ATTACHMENT 1

PROPOSED SNUBBER FUNCTIONAL TESTS
TECHNICAL SPECIFICATION CHANGES

JUSTIFICATION AND SAFETY ANALYSIS

FIGURE 4.7-1
SAMPLE PLAN 2) FOR SNUBBER FUNCTIONAL TEST

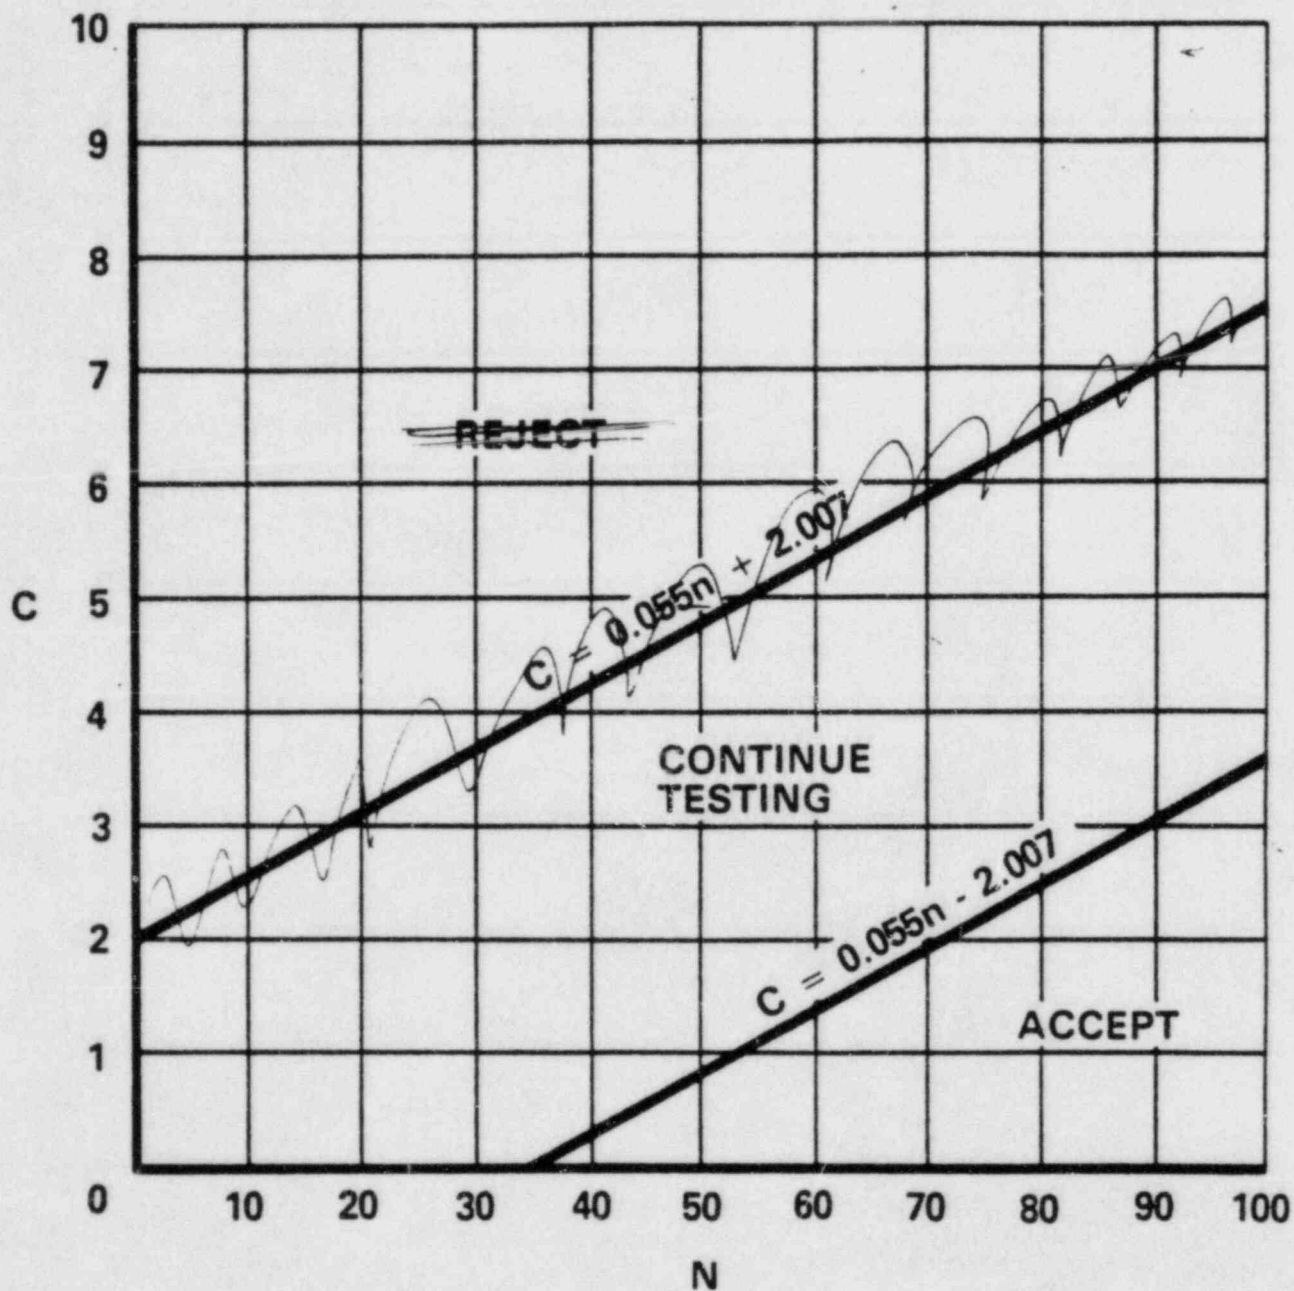
- 2) A representative sample of the snubbers required by Specification 3.7.8 shall be functionally tested in accordance with Figure 4.7-1. "C" is the total number of snubbers found not meeting the acceptance requirements of Specification 4.7.8f (FAILURES). The cumulative number of snubbers tested is denoted by "N." ~~At the end of each day's testing, the new values of "N" and "C" (previous day's total plus current day's increments) shall be plotted on Figure 4.7-1. If at any time the point plotted falls in the "Reject" region all snubbers shall be functionally tested.~~ If at any time the point plotted falls in the "Accept" region, testing of snubbers may be terminated. When the point plotted lies in the "Continue Testing" region, additional snubbers shall be tested until the point falls in the "Accept" region ~~or the "Reject" region~~, or all the snubbers required by Specification 3.7.8 have been tested. Testing equipment failure during functional testing may invalidate that day's testing and allow that day's testing to resume anew at a later time, providing all snubbers tested with the failed equipment during the day of equipment failure are retested; or

TEST RESULTS SHALL BE PLOTTED SEQUENTIALLY IN THE ORDER OF SAMPLE ASSIGNMENT (I.E. EACH SNUBBER SHALL BE PLOTTED BY ITS ORDER IN THE RANDOM SAMPLE ASSIGNMENT NOT BY THE ORDER OF TESTING).

1. Functionally test 10% of a type of snubber with an additional 10% tested for each functional testing failure, or
2. Functionally test a sample size and determine sample acceptance or ~~rejection~~ using Figure 4.7-1, or
CONTINUE TESTING*
3. Functionally test a representative sample size and determine sample acceptance or rejection using the stated equation.

* IF TESTING CONTINUES TO BETWEEN 100-200 SNUBBERS (OR 1-2 WEEKS) AND STILL THE ACCEPT REGION HAS NOT BEEN REACHED, THEN THE ACTUAL % OF POPULATION QUALITY (C/N) SHOULD BE USED TO PREPARE FOR EXTENDED OR 100% TESTING.

FIGURE 1

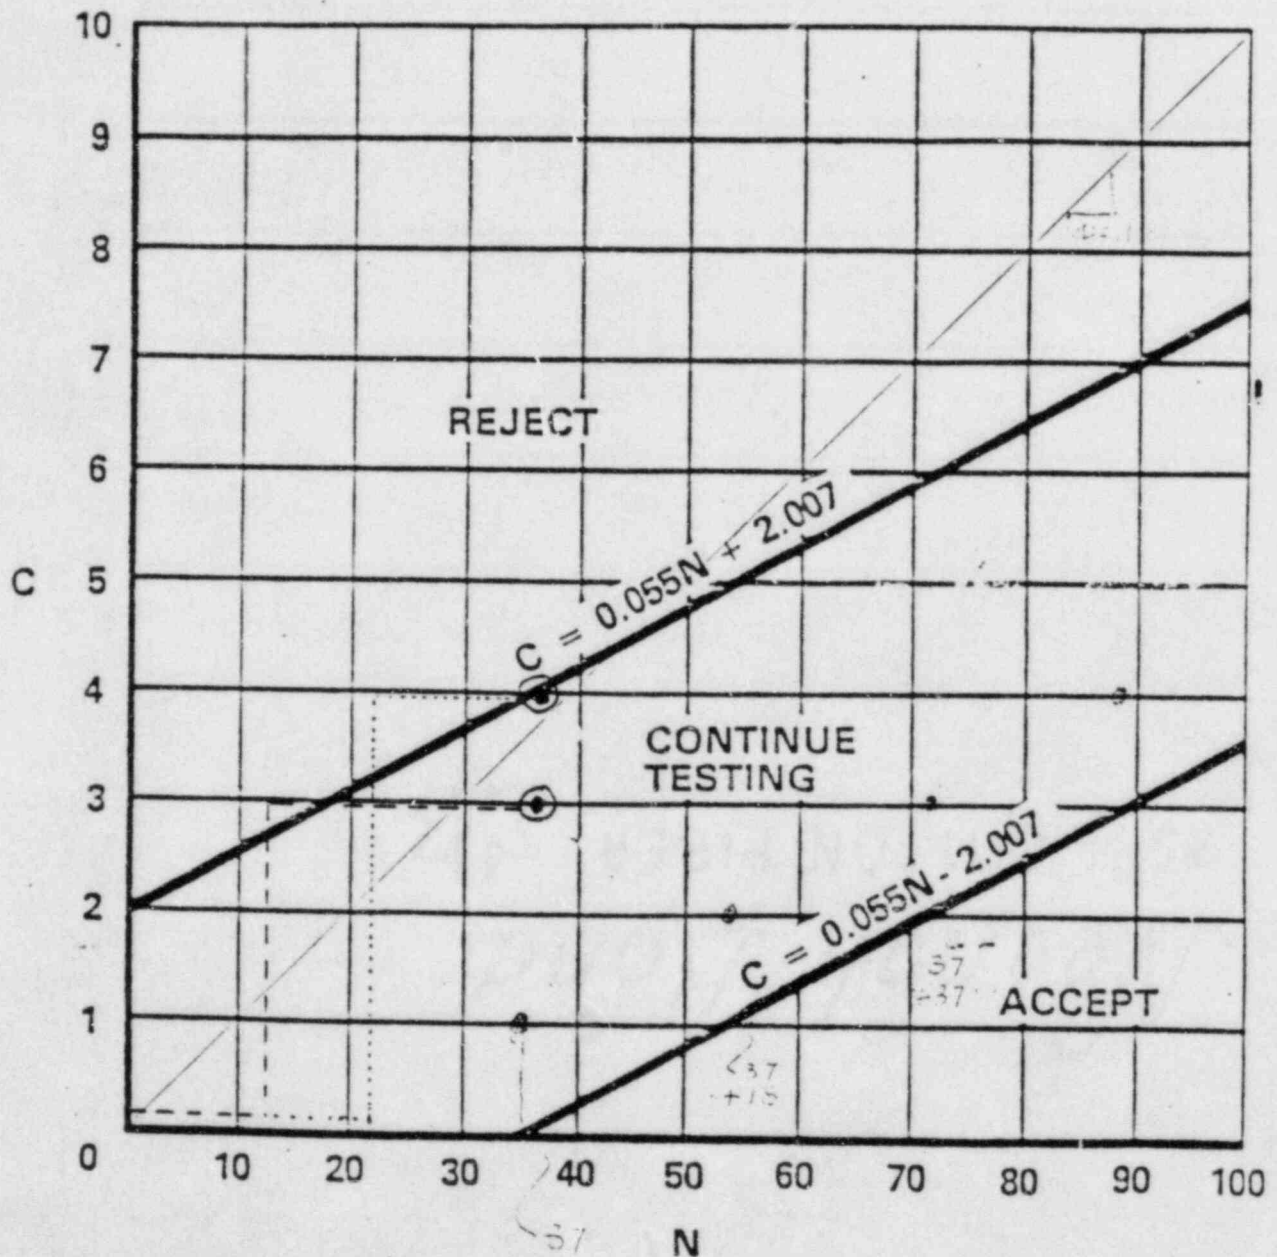
The concerns with the "37" Plan in OM-4 were: 1) the necessity of the reject line (Figure 1 Tech. Spec. 4.7.8), and 2) when and how to plot test results (sequentially, at the end of the sample, or at the end of the day). Both concerns were resolved in light of statistical evidence which eliminated the practical need for the reject line (reference Attachment 2A). Elimination of the reject line in turn resolved the issue of test results plotting: it is to be plotted sequentially in the order of sample selection; not by testing order. Based on these conclusions a re-write of the OM-4 draft document was agreed to by all present. In light of these agreed-upon changes to the OM-4 document and due to the practical risk (2%) of rejecting a good population (necessitating 100% functional test) with the current "37" Plan Reject Line (Tech. Spec. 4.7.8.e Plan 2), changing the current MNS 1 and 2 Tech. Spec. will alleviate any possibility of unnecessary 100% testing of the McGuire Unit 1 and/or 2 snubber populations during future refueling outages. The changes allow for deletion of the reject line in McGuire T.S. Figure 4.7-1. As long as the reject line remains in the plan there is some possibility of rejecting a good population which would consequently require an unnecessary 100% testing of approximately 1600 snubbers with attendant ALARA and safety concerns (e.g., due to decontamination efforts, testing of "hot" snubbers, danger in physically accessing/removing certain snubbers), manpower utilization, outage extension, and other problems.

A major change in the reject line caused only a tiny change in the accept line, while continuing to accept a marginal population (10% Bad) only 5% of the time. In a practical sense, that proves that acceptance is independent of rejection. Since when we plot impacts only on rejection, acceptance is independent of when we plot.

FIG 2

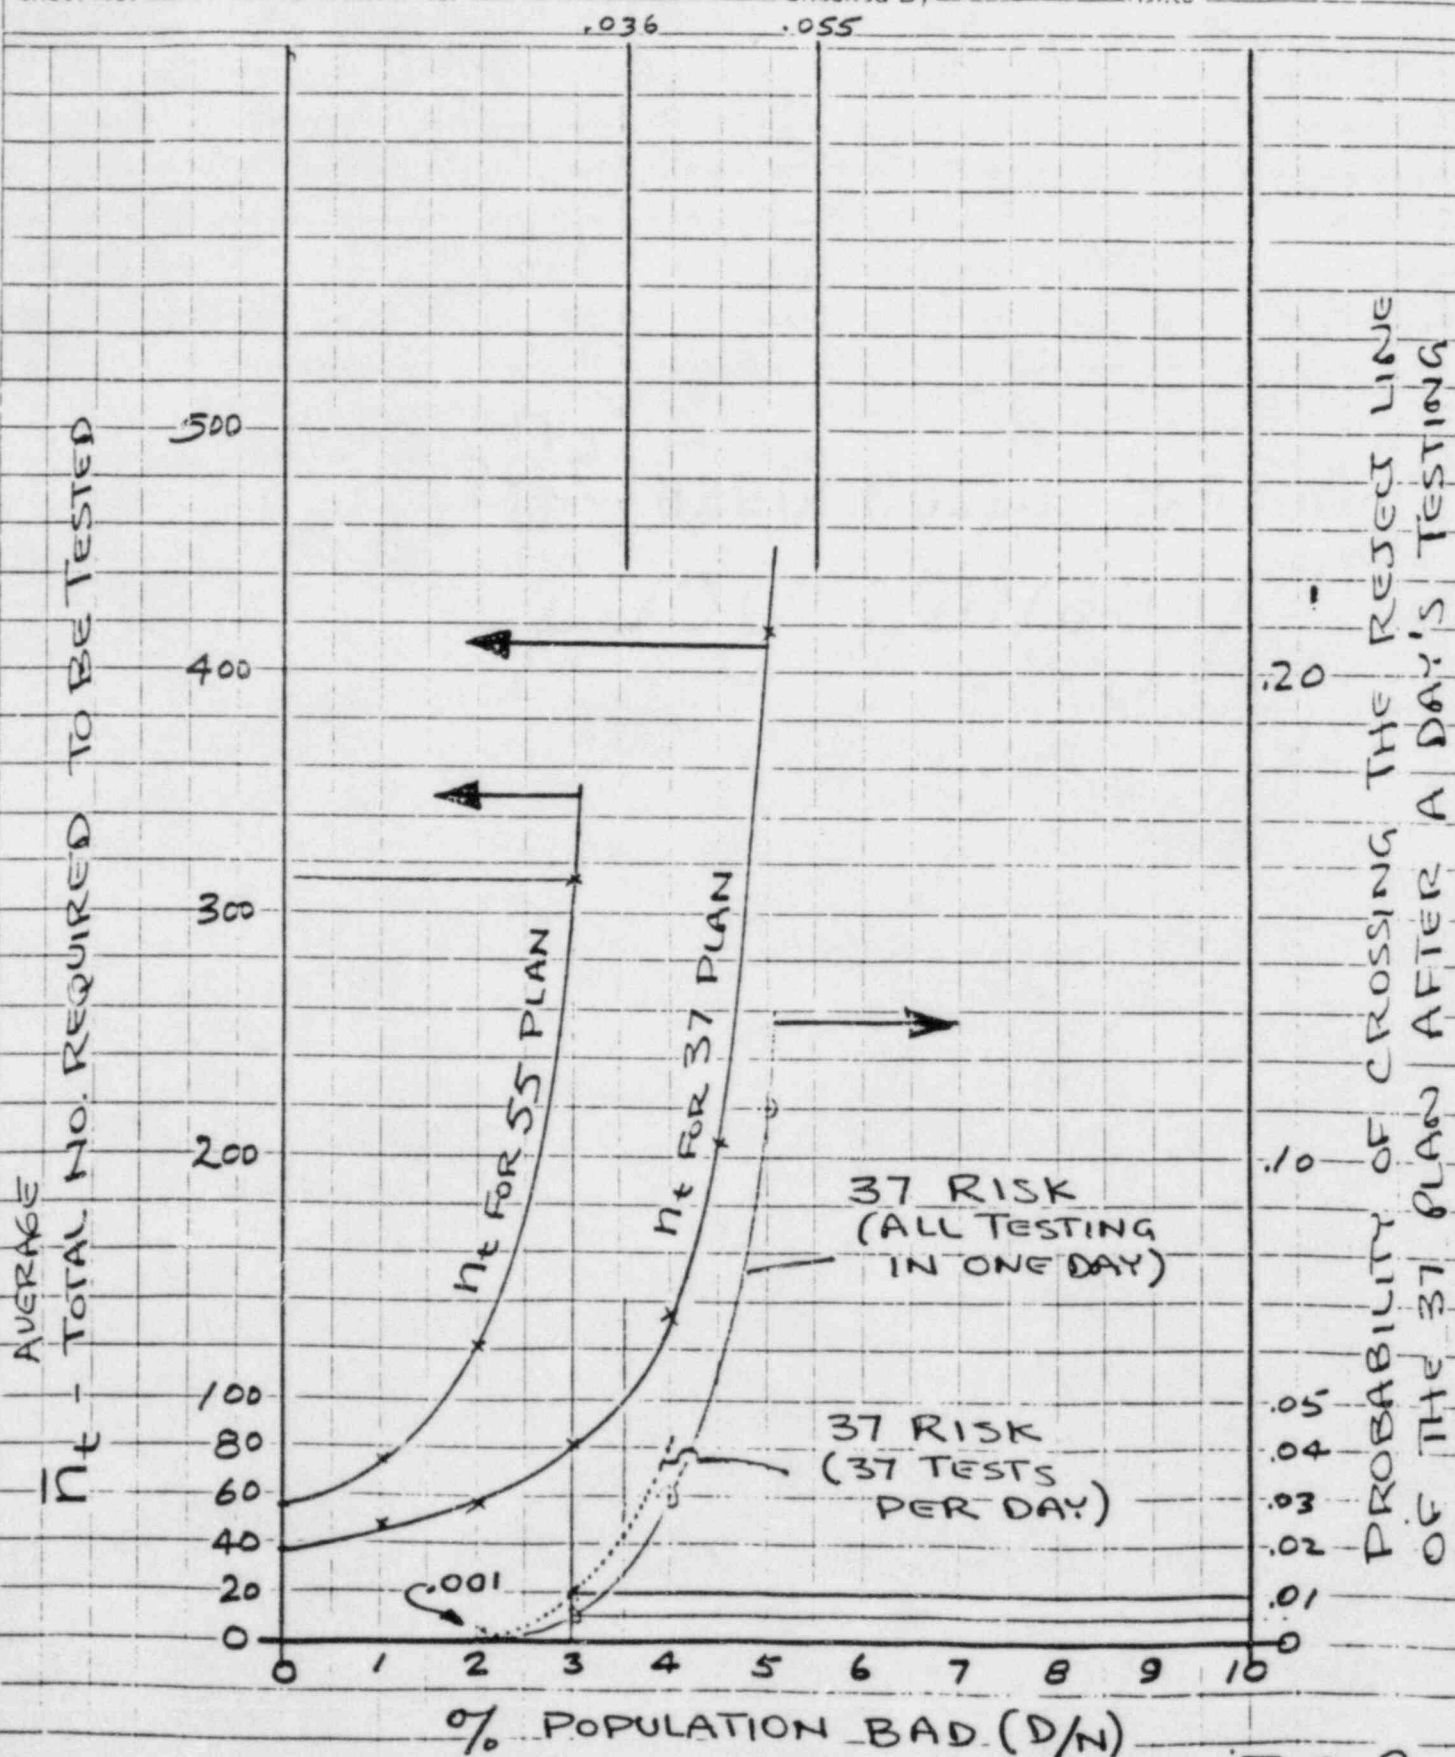
We should confirm our judgement that P_1 should be in the 2.5% range. I believe the confirmation is in the curves plotted on Figure 2. The amount of testing required and the risk of rejection are clearly unacceptable at 4% bad (37 Plan), and, at 2 + % with the 55 plan. (We'll have more confidence in our calculation of the risk of rejection by the 3/7/85 meeting.) If I were free to do it over, I believe I would pick P_1 between 2% and 2½%, $\alpha = .01$.

SERIES I

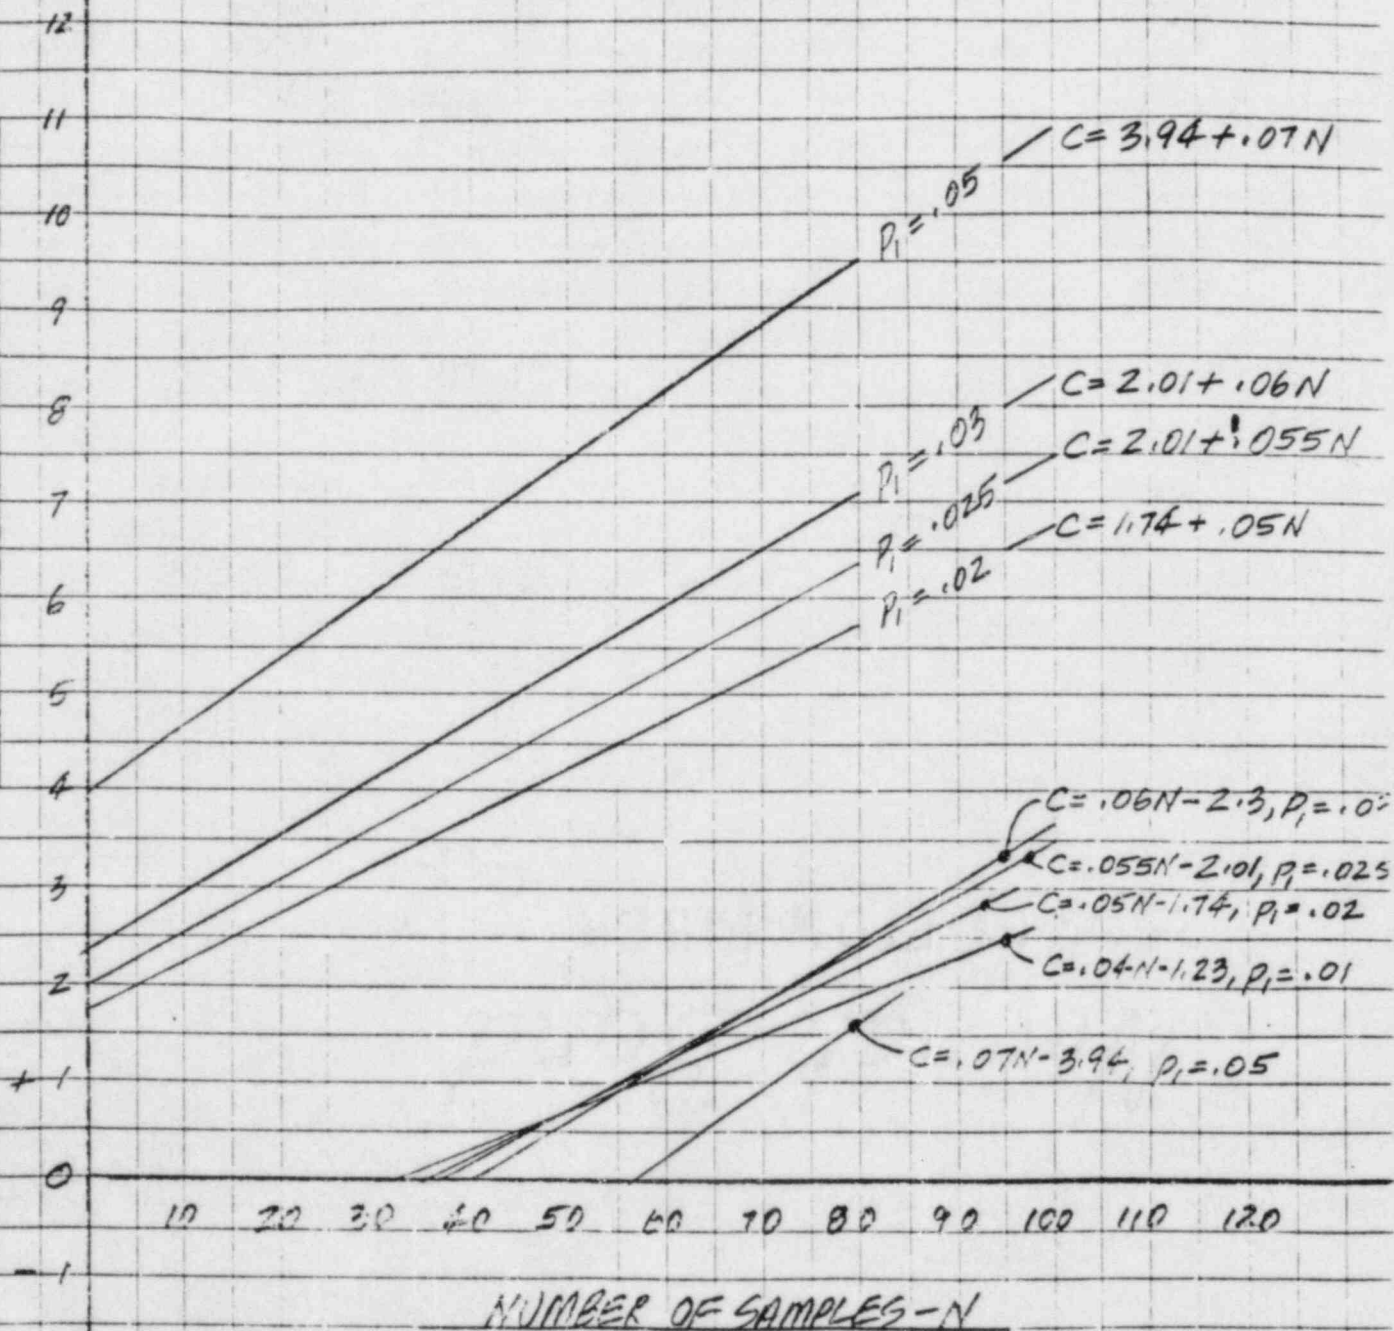
The results of Series I seem most interesting. Changing α , the probability of rejecting a good population had no significant impact on the accept line. The slopes were identical, and for α varying from .10 to .001, the lower intercept (H_L) changed only from 1.97 to 2.04. On the other hand, the smaller we made α , the higher the reject line went. When we set $\alpha = 0$, the reject line disappeared completely ($H_U \rightarrow \infty$).

Inspection of the equations shows why this occurs. α & β are not in the slope equation, and α is a very weak parameter in the h_p equation.

SERIES II

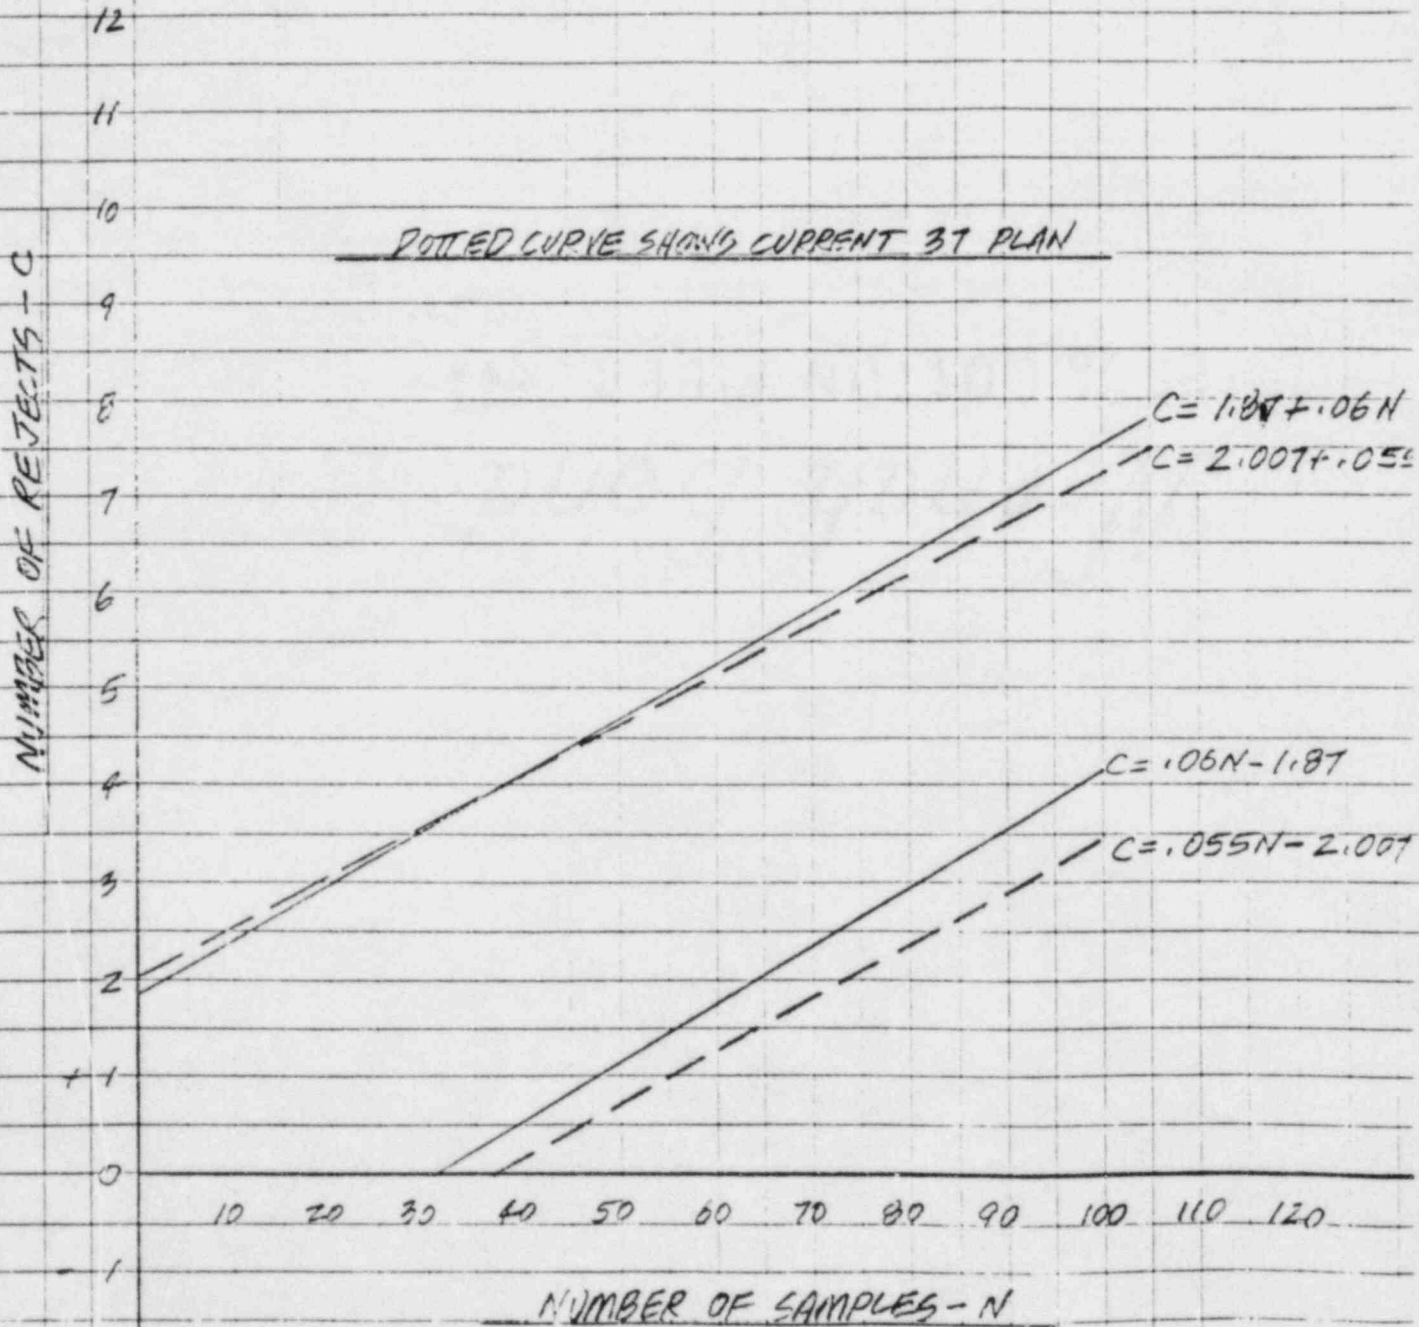
Series II, Wald curves show a dependence of the accept line on P_1 , the estimated quality of a good population. The curves are bunched up to $P_1 = .03$, with slope and intercepts offsetting in the region of interest. At $P_1 = .04$ the offset effect begins to dominate, and at $P_1 = .05$ the effect is clear.
